Substantive response of the Local Highway Authority to a planning consultation received under The Development Management Order.

Planning Application Number: 24/00264/OUT

Application Address: Land North Of Normandy Way Hinckley Leicestershire

Description of Application: Re-consultation. Outline planning permission for the erection of up to 415 dwellings, including landscaping, open spaces, drainage and associated infrastructure (outline - access only)

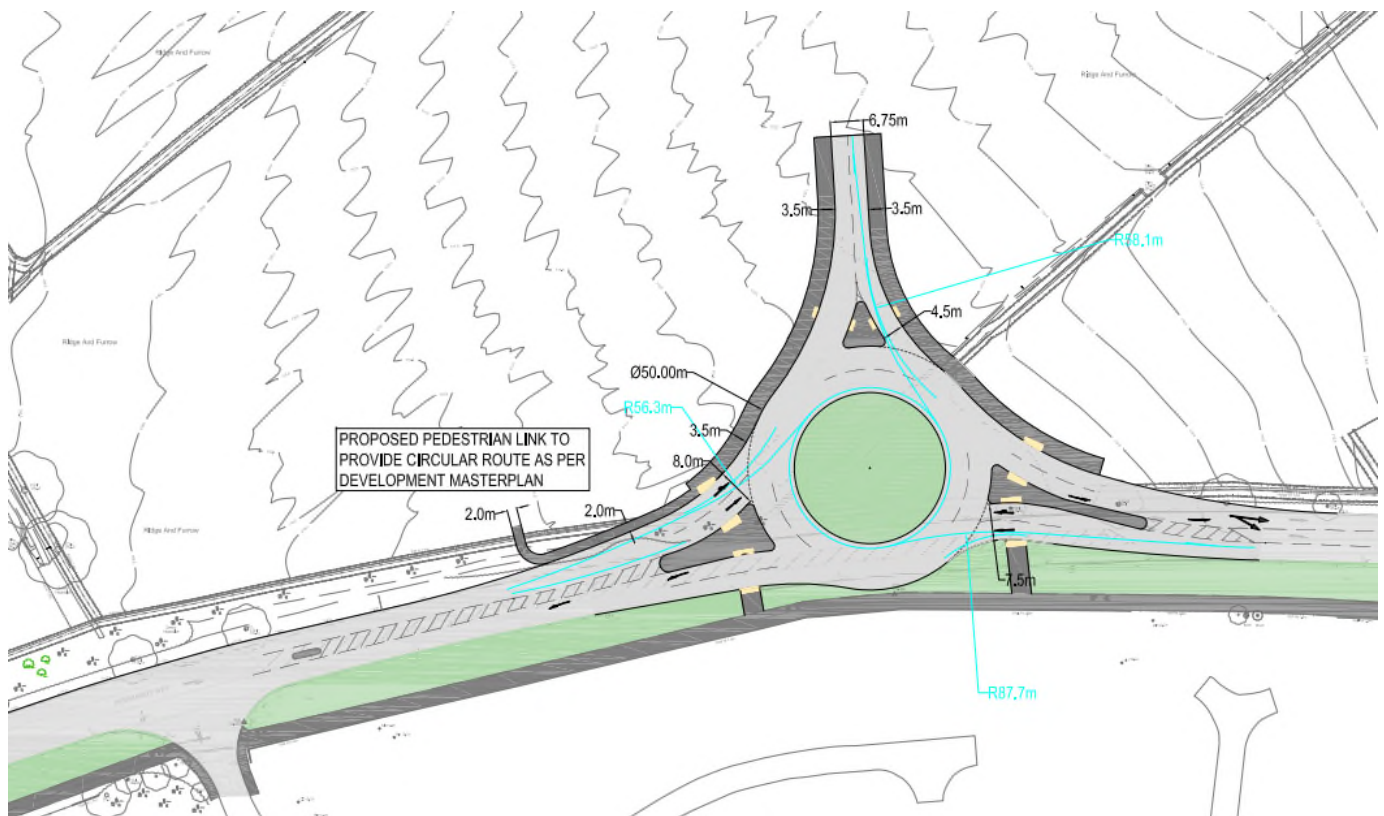
Normandy Way is an A classified road, subject to a 40 mph speed limit. The single point of vehicle access to the site will be provided via a 3-arm roundabout on Normandy Way. Two arms are a continuation of Normandy Way with the third arm proposed to serve the development. A shared footway/cycleway provision is proposed along the northern arm (site access), which will connect to the existing footway/cycleway provision via informal crossing points. The proposed access is demonstrated in Drawing T23548.001 Rev D of which an extract is shown below and proposes a 6.75m carriageway width for the site access arm.

The LHA note that no Stage 1 Road Safety Audit has been provided, which should be included as part of this submission along with the designer's responses to any issues raised in the audit.

The following geometric information should be provided for the proposed roundabout and demonstrated on a scale drawing: circulatory carriageway width, central island diameter, entry kerb radius, exit Widths, exit kerb radius, entry angle.

Entry lane widths are in accordance with DMRB CD116, as are the entry path radii and inscribed circle diameter (ICD) shown on the drawing.

The LHA note that the location of the proposed roundabout requires an existing ghost right turn junction to be amended. Dimensions for the adjusted ghost island right turn lane to the east of the roundabout should be provided, in accordance with Table 5.22 of the DMRB CD123. These should include the lane widths, turning length, deceleration length and the direct taper length.

Visibility splays should be provided on the drawing confirming that the Stopping Sight Distance on the approach to the roundabout are in accordance with DMRB CD116.

The proposed 6.75m width of the roundabout arm serving the development is in accordance with the Leicestershire Highways Design Guide (LHDG) Table DG1.

The existing highway boundary and the proposed land take required for the proposed works should be provided on a drawing.

The LHA recommends a vehicle speed of 15kph is used for swept path analysis. A note should be added to the drawing confirming this.

The length of the Max Legal Length Articulated Vehicle has increased from 16.5m to 18.55m (in May 2023); this should be reflected in the swept path analysis.
